**WLB3 - Replacing Ground Point for External Power Connection (Workshop Campaign)**

Model line: **Taycan (Y1A)**

Subject: **Ground point for external power connection**

*Removing ground screw*

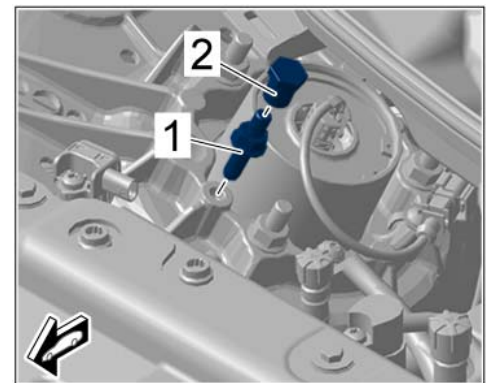
Information: **A ground screw for the external power connection that has too much specific resistance due to its surface condition was installed on the affected vehicles.**

As a result, the vehicle electrical system battery cannot be sufficiently charged due to the excessive contact resistance between the terminal clamp and ground screw.

2 Loosen and unscrew old ground screw ⇒ *Removing ground screw-1-*.

Remedial Action: Replace ground screw for external power connection with a double screw and contact pin with an optimized surface.
